## Proposed Burlington Quarry Expansion JART COMMENT SUMMARY TABLE – Hydrogeology

JART Comments (February 2021)	Reference	Source of Comment	Applicant Response	JART Response
<b>Report/Date: Level 1 and Level 2 Hydrogeological and Hydrological Impact Assessment Report, April 2020</b>				<b>Author: Earthfx Incorporated</b>

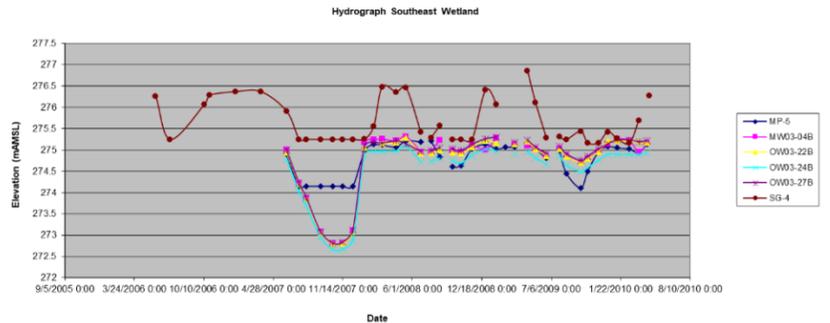
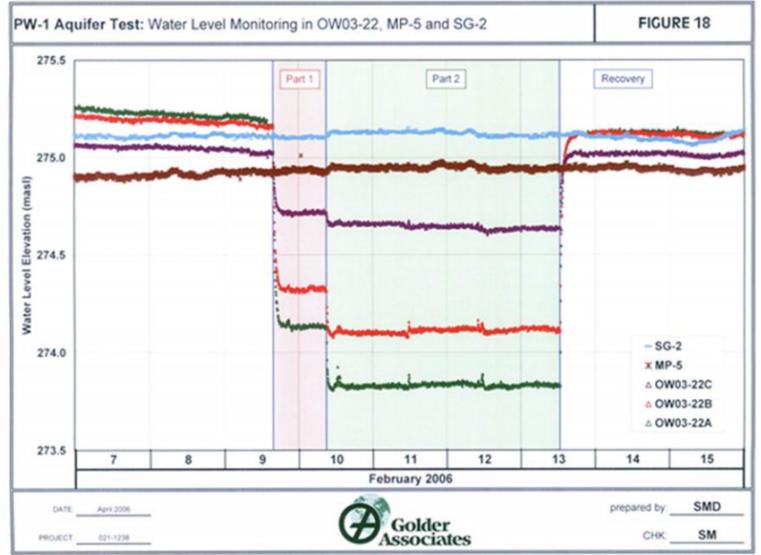
27.	This behaviour was, in fact simulated for Wetland 13032 (Figure 1). Following snowmelt and early precipitation from late March through early April, the water level gradually declines, responding only to rainfall events (as shown by each of the slight upticks) through the season reaching annual lows in late July/early August.	General	Daryl W. Cowell & Associates Inc.		
	<p>Figure 1. Simulated water level showing a spring recession pattern typical of wetlands underlain by low permeability materials (Figure 6.35 for Wetland 13032 in the Level 1 and 2 Hydrogeological Assessment). In this simulation, lowest wetland water levels are not achieved until August – September.</p>

28.	However, this pattern is not demonstrated in all wetlands located on the site. Table 42 (page 86) in the Surface Water Assessment report indicates that levels in at least four wetlands (SW11/13027; SW12/13022; SW13/13016) and SW16/13201) all reach “0” (based on 0.0 metre reading on staff gauge) prior to late May on the 20-year	General	Daryl W. Cowell & Associates Inc.

Figure 1a. Location of springs A to K, sinking streams near the quarry, and locations of the photos (circled numbers) shown in Figures 2 to 7.

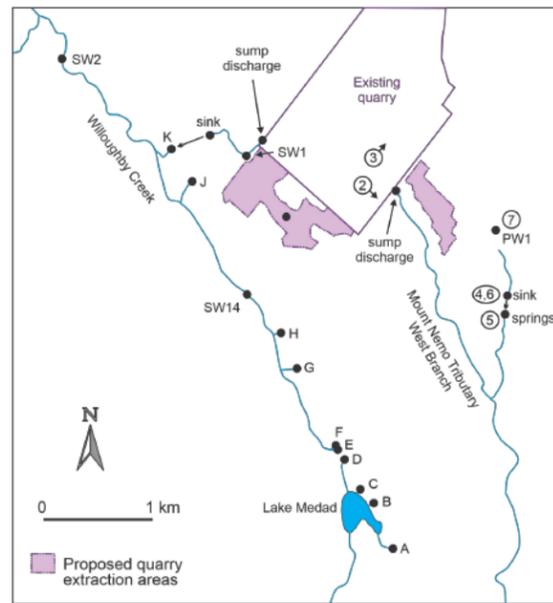
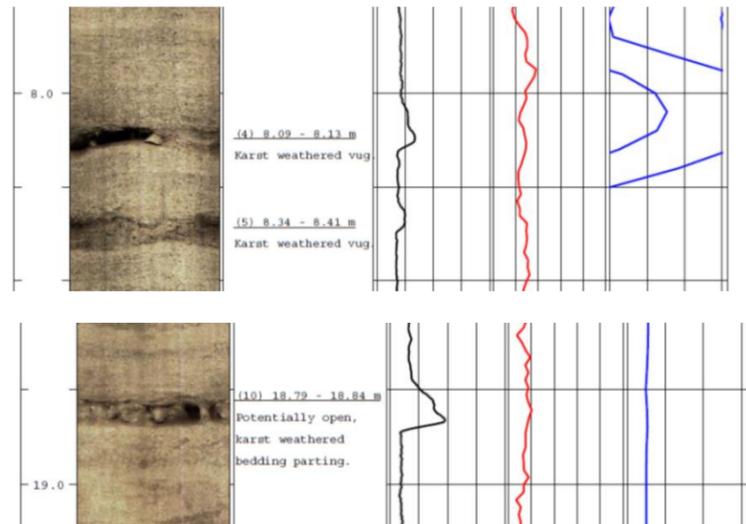
41.	Worthington (2006 and 2020) documented the presence and location of 10 springs in the Medad Valley. He provided one-time flow estimates (March 23, 2006) that ranged between 3.0 and 32.0 litres/second at the time of observation. Springs G, H, J, and K are all within about 1.0 kilometre of the western extension and spring J is within about	General	Daryl W. Cowell & Associates Inc.

500.0 metres (see Worthington Figure 1a below). These four springs have a combined flow estimated at 45.0 litres/second.

Photograph of the gorge of the Niagara River across from the Hyde Park Landfill site [Photograph by C. Neville]

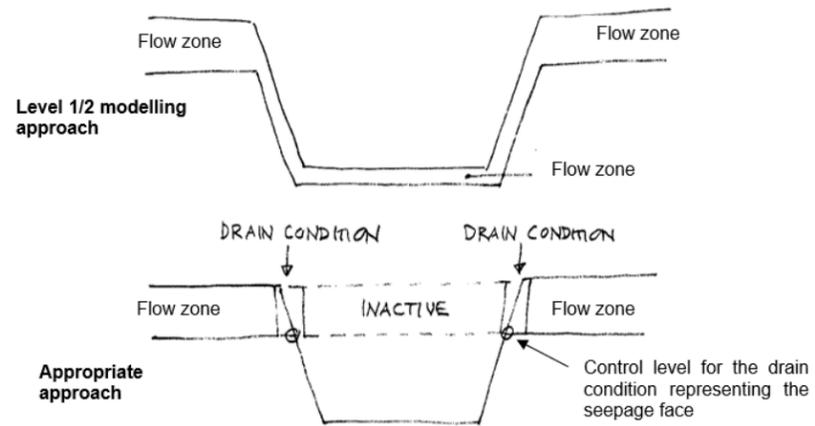
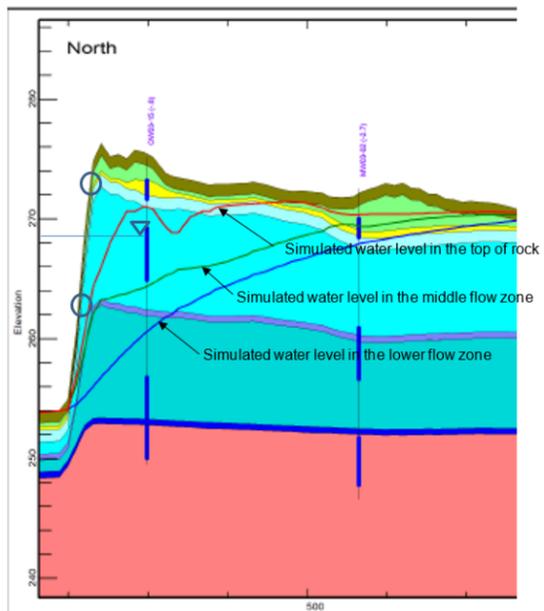
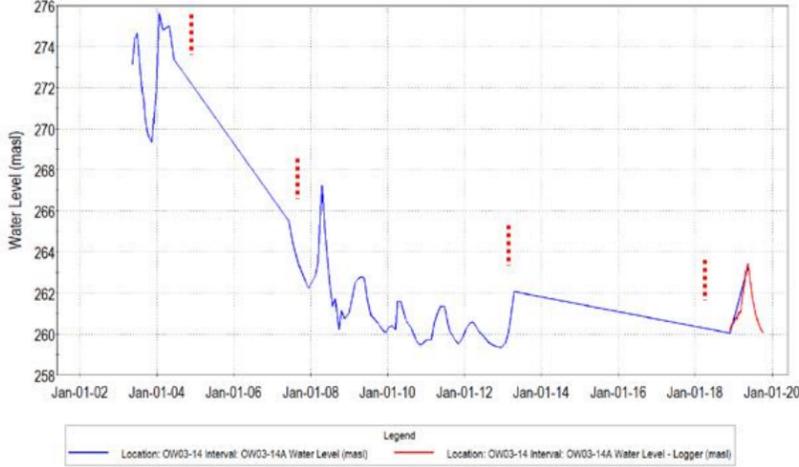
114.	It is indicated on page 92 that the layers of the MODFLOW and GSFLOW models must be continuous across the model domain. This requirement has been interpreted in a way that is considered to be non-physical. The results close to the deep cutting	Page 92 and Figures 5.2-5.4 and 19.18-19.20	S.S. Papadopulos & Associates, Inc.

features, including the Medad Valley and the existing quarry are not realistic. An excerpt from a cross-section through the model along 2<sup>nd</sup> Side Road is reproduced below (Figure 5.2). As shown in the figure, the model layers are “pushed down” below the base of the Medad Valley.

This is not a realistic representation of the bedrock flow zones in the rocks of the Niagara Escarpment. For example, a view across the gorge of the Niagara River downstream from Niagara Falls is shown on the next page. Rather than diving down below the Niagara River, the bedrock flow zones daylight at the gorge. Groundwater exits at the base of each flow zone, forming stacked seepage faces.

A physically realistic approach for representing this situation is shown schematically below.

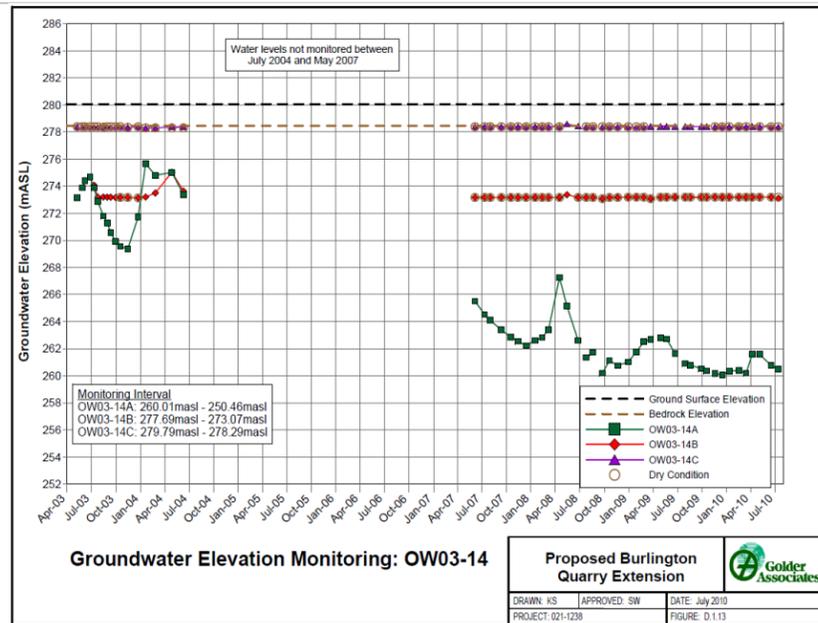
The results shown in Figures 5.2-5.4 and 19.18-19.20 of the report illustrate why the representation of conditions along the Medad Valley and Niagara Escarpment and around the existing quarry is important. A portion of Figure 19.18 is reproduced below. There is no evidence to suggest that the water levels in the weathered top-of-rock and in the middle flow zone decline steeply as predicted with the model. Hydrographs for observation well OW03-15 between April 2003 and July 2010 and between July 2009 and January 2015 are reproduced here on page 9. The long-term average water levels in the shallow “C” and deeper “B” and “A” monitoring intervals are about 273.0 metres, 269.0 metres and 259.0 metres amsl, respectively. Since 2003, the water levels have varied by only about  $\pm 1.0$  metre with respect to the average levels. The water levels are controlled by the elevations at which the flow zones daylight at the quarry, indicated by the circles added to the excerpt from Figure 19.18. The non-physical simulation approach that has been adopted compromises severely the reliability of predictions of potential impacts of the quarry extension.

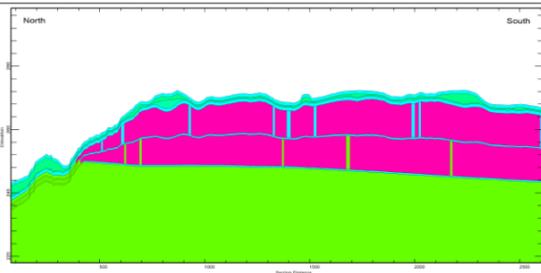
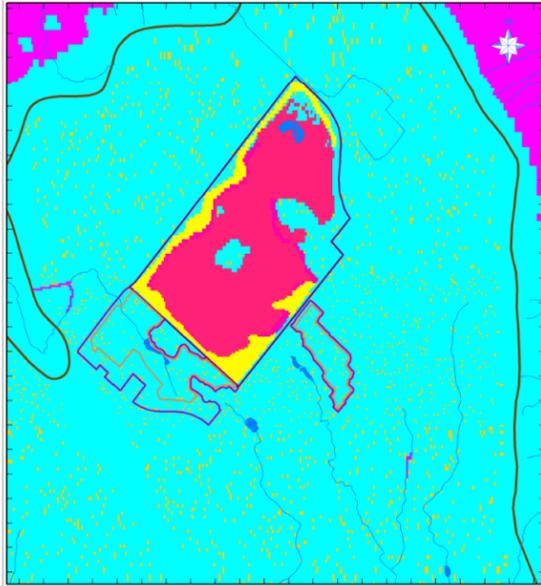
322.	<p>'The test response for the Westerns Lands is unique in terms of the unconfined response and is attributed to the local setting at the pumping well. This is stated since the bedrock profile at the pumping well is overridden by a thickness of sand which has not been seen elsewhere on the Western Lands and the Southern Lands. This delayed response (i.e., late-time unconfined response) is attributed to the overlying sand sequence as opposed to the larger interconnected fractured rock network. This also accounts for the fact that the same response was not observed during the former Golder pumping test sequences (Golder, 2006). The clay till overburden evident over the regional setting has no capacity to yield any significant response. '</p> <p>The pump test was able to assess the hydraulic conductivity of the bedrock aquifer. No borehole logs of the test wells BS-06 and BS-07 were provided to confirm the bedrock intervals that were tested. The lack of groundwater monitors within the overburden shallow water table prevented an assessment of the degree of leakage from surface and the degree of interconnection between surface water features such as wetlands and the underlying bedrock. Pumping test of the bedrock should include a groundwater monitor completed within the overburden to assess the interconnection between the overburden and bedrock. Monitoring of nearby surface water features should also be conducted during the pumping test. The pumping test should be of sufficient length to determine the degree to which there is hydraulic connection between the overburden and bedrock.</p>	Page 378 2 <sup>nd</sup> Paragraph Section 15.2.2.2. Pumping Test Interpretation	Norbert M. Woerns

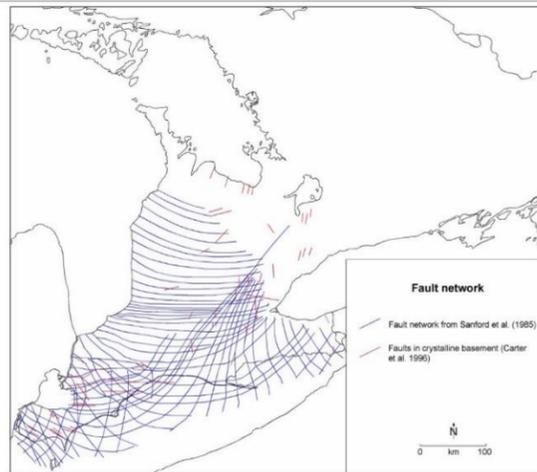
338.	<p>The expectation is that the horizontal and vertical hydraulic conductivity of the Halton Till is a critical parameter in the analyses, particularly the vertical hydraulic conductivity. Are the values of the horizontal and vertical hydraulic conductivities inferred through calibration, <math>5.0 \times 10.0^{-7}</math> metres/second and <math>2.0 \times 10.0^{-7}</math> metres/second (Table 18.4) consistent with estimates reported for other sites?</p> <p>A compilation of hydraulic conductivity estimates for the Halton Till is reproduced below (Gerber and Howard, 2000).</p>	Table 18.4	S.S. Papadopulos & Associates, Inc.

<p>Gerber (2010) has suggested the following representative average values for the Halton Till (Gerber, 2010):</p> <ul style="list-style-type: none"> <li>• Weathered Halton Till: <math>K_H \sim 5.0 \times 10^{-6}</math> metres/second; <math>K_V = K_H</math>; and</li> <li>• Unweathered Halton Till: <math>K_H \sim 5.0 \times 10^{-7}</math> metres/second; <math>K_V = 0.1 K_H</math>.</li> </ul> <p>Sharpe et al. (2013; Table 4) suggest a value of <math>2.0 \times 10^{-5}</math> metres/second for the vertical hydraulic conductivity of the weathered Halton Till.</p> <p>The value of the vertical hydraulic conductivity of the Halton Till inferred through calibration appears to be substantially smaller than literature values. This is not to imply that the values specified in the groundwater model are inappropriate. However, there is no discussion of how the values were inferred through calibration. How sensitive is the match of the calibration targets to the values of the vertical hydraulic conductivity of the Halton Till that are specified? How sensitive are the predictions to the vertical hydraulic conductivity of the Halton Till, in particular the predicted impacts to shallow features such as wetlands?</p>
